Cc: Countryman, Ryan; Mock, Barb; McCrary, Mike; Dobesh, Michael **Subject:** Point Wells -- Design Review Board recommendation re Building

Heights

To: Snohomish County Design Review Board

This page is marked to show the number of stories per building in the applicant's alternate 90-foot plans

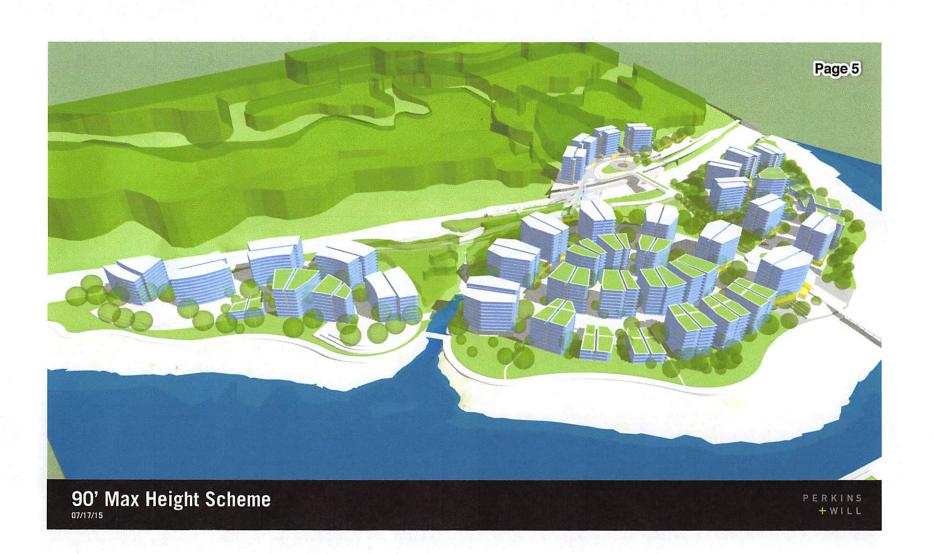
Out of 45 buildings, all but seven are nine stories high, producing an institutional, unattractive, dormitory-style development.
